PORT OF PORT ARTHUR
NAVIGATION DISTRICT OF JEFFERSON COUNTY, TEXAS

ADDENDUM 1

IMPROVEMENTS TO CATHODIC PROTECTION SYSTEM
FOR BULKHEAD AT BERTHS 3 AND 4

POPA FILE: 8.329

DRAWING NO.
CP-11

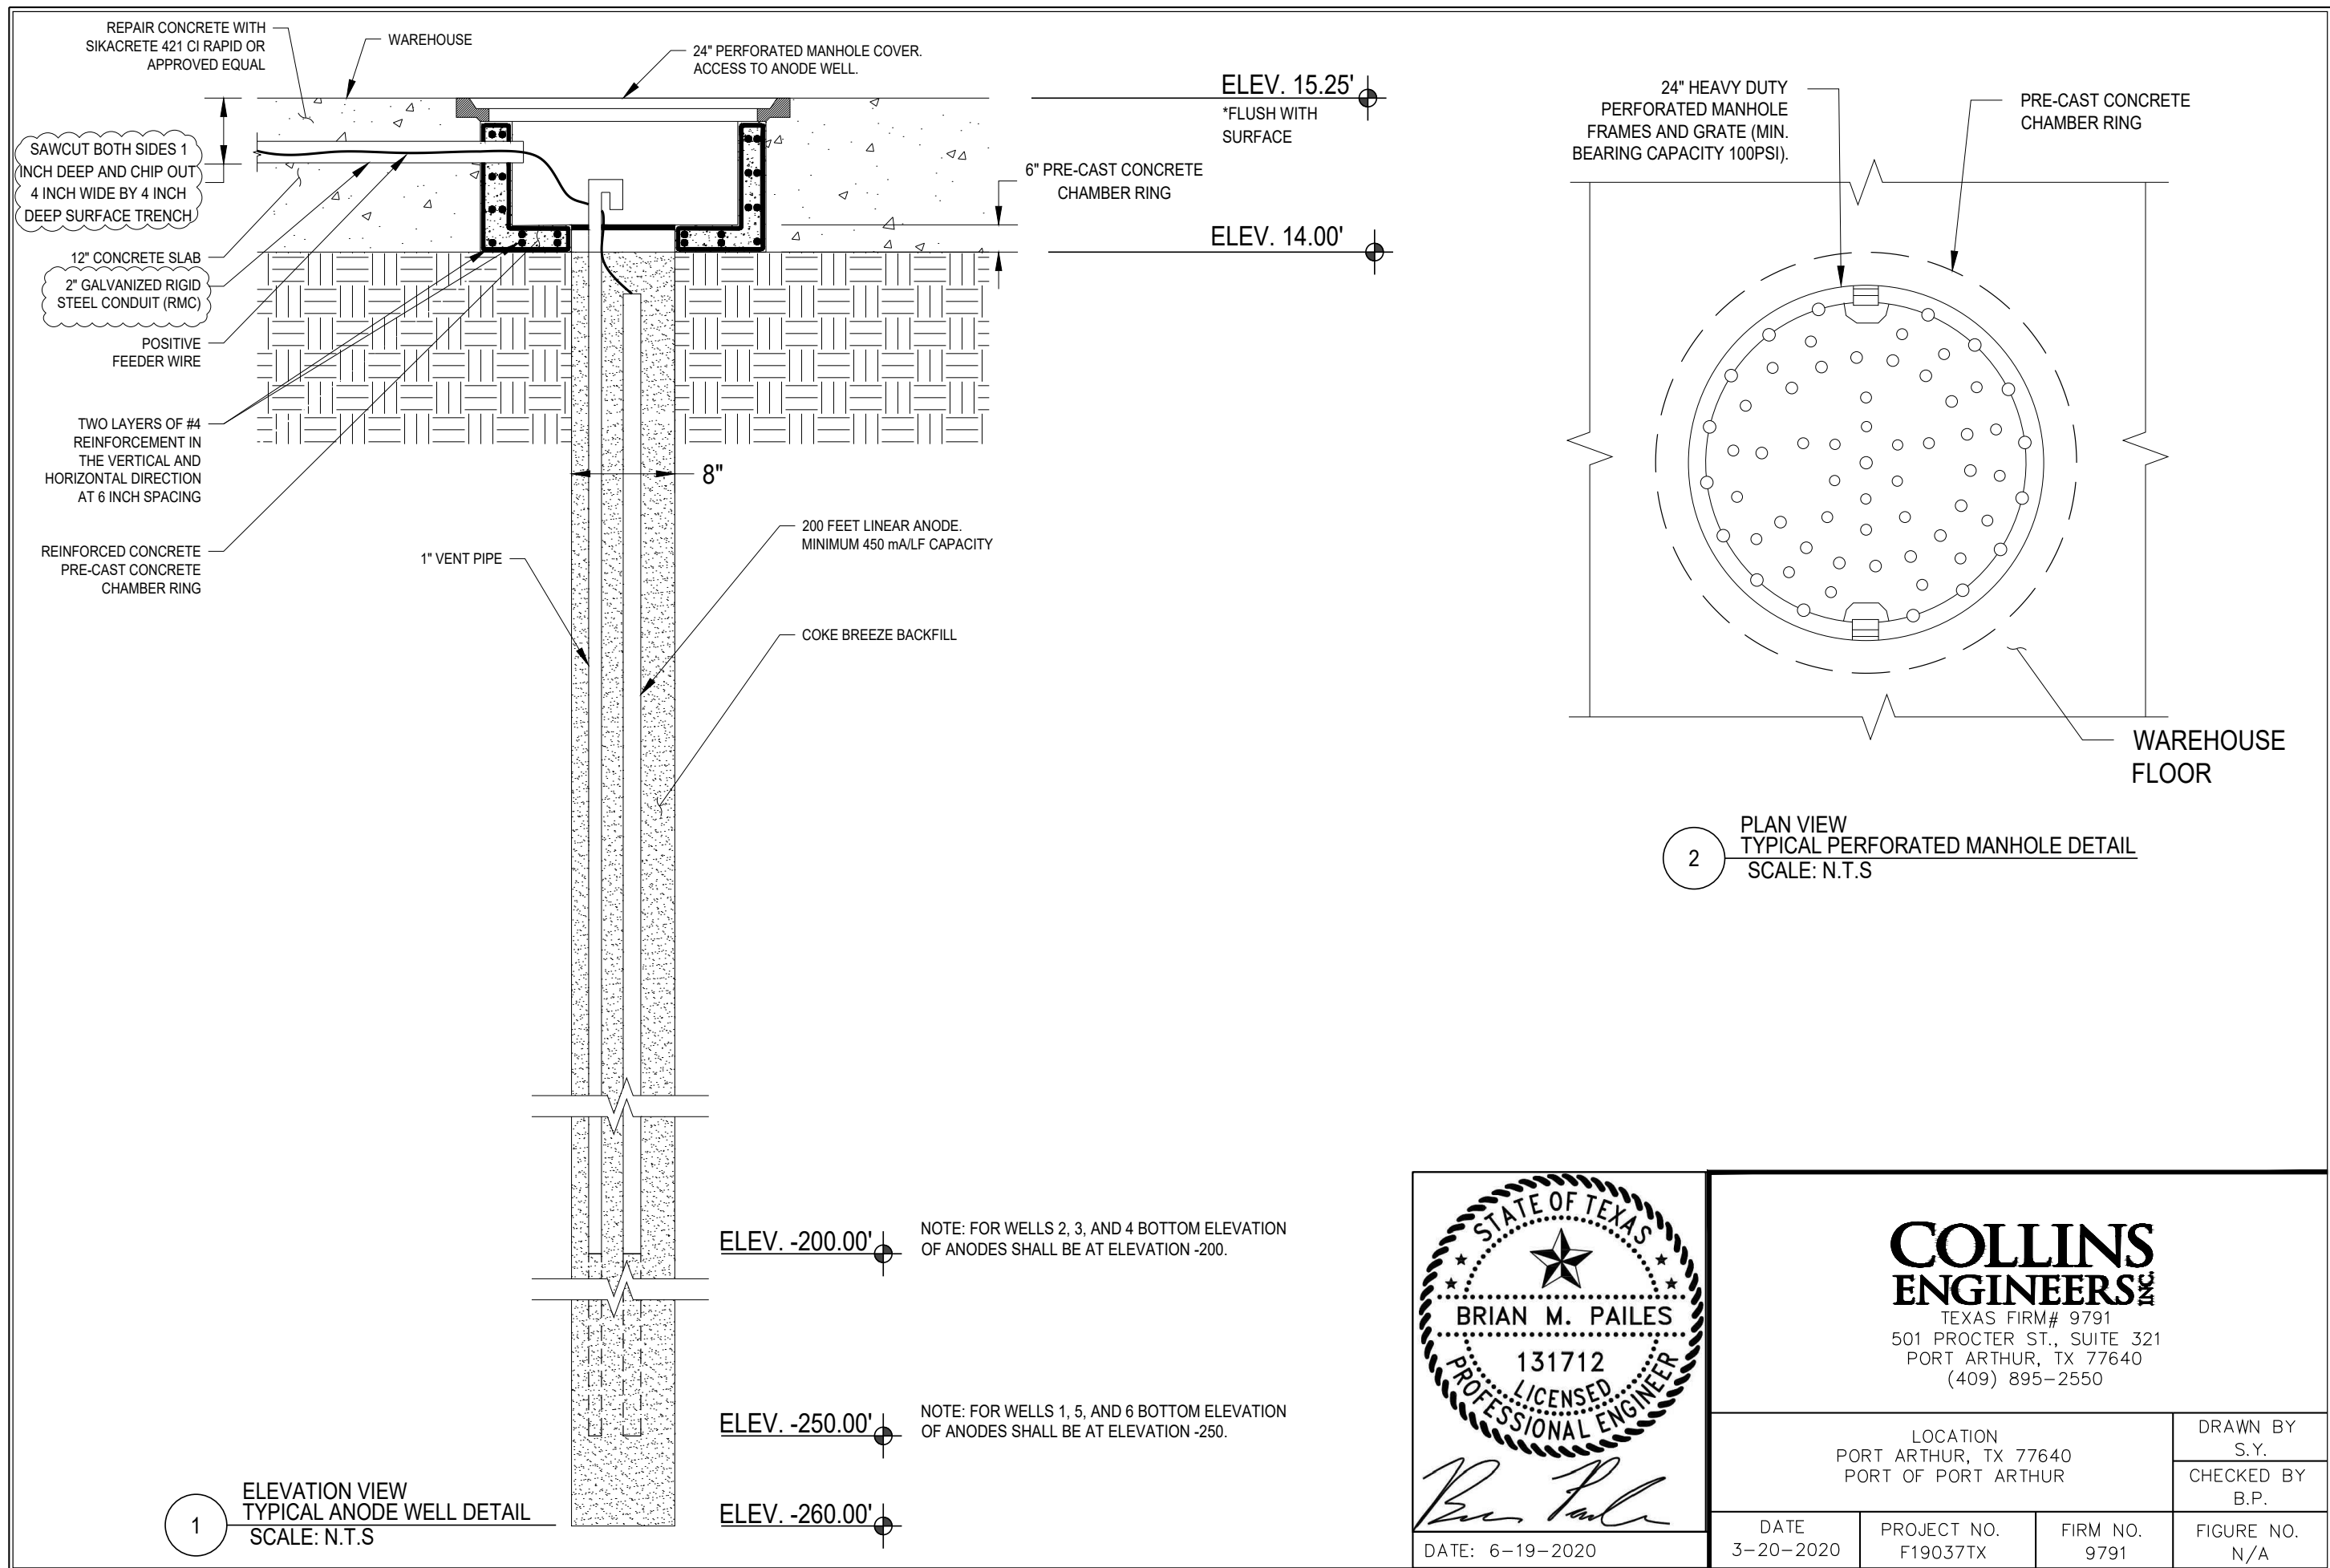
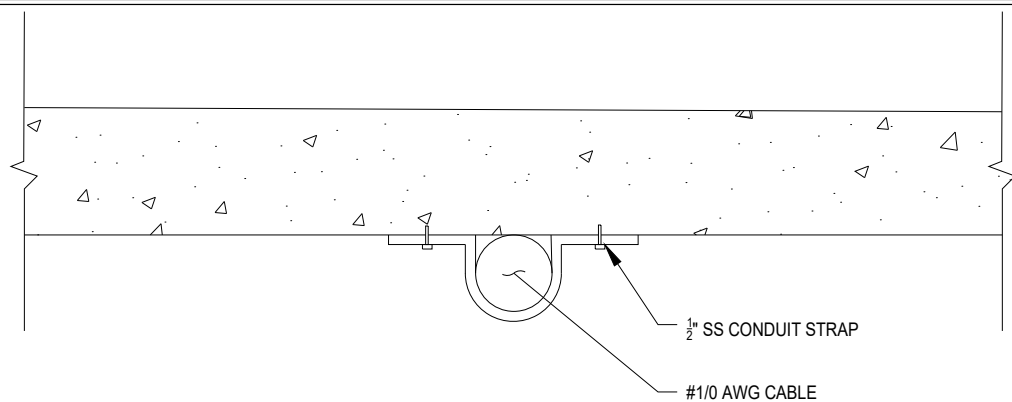
7. The PORT OF PORT ARTHUR IMPROVEMENTS TO CATHODIC PROTECTION OF BULKHEAD AT BERTHS 3 AND 4 Construction Drawings have been revised. The new document has been included in this Addendum. Changes include modification to the locations of the new rectifiers as shown in CP-2, modification to the elevations for the bottom of the anodes as shown on drawings CP-11 and distance from column to

deep wells in RUBB have increased to 10 ft. The new document has been attached as part of this Addendum.
